World Forum for Harmonization of Vehicle Regulations

Proposal for Supplement 6 to the 04 series of amendments to Regulation No. 48 (Installation of lighting and light-signalling devices)

Submitted by the Working Party on Lighting and Light-Signalling (GRE)*

“Figure 1a: Rear

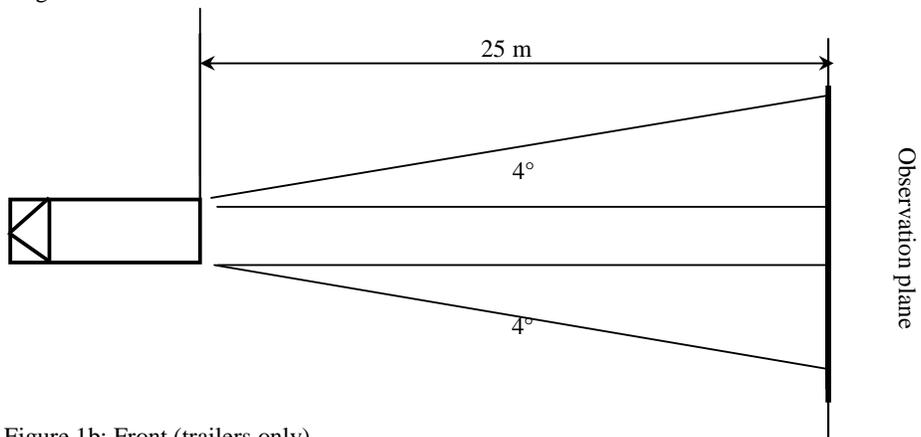
Annex 11, amend the figures to read:

- “6.21.5.1. for rear and front conspicuity markings (see Annex 11, Figures 1a and 1b) the observation plane is perpendicular to the longitudinal axis of the vehicle situated 25 m from the extreme end of the vehicle and bounded by:”
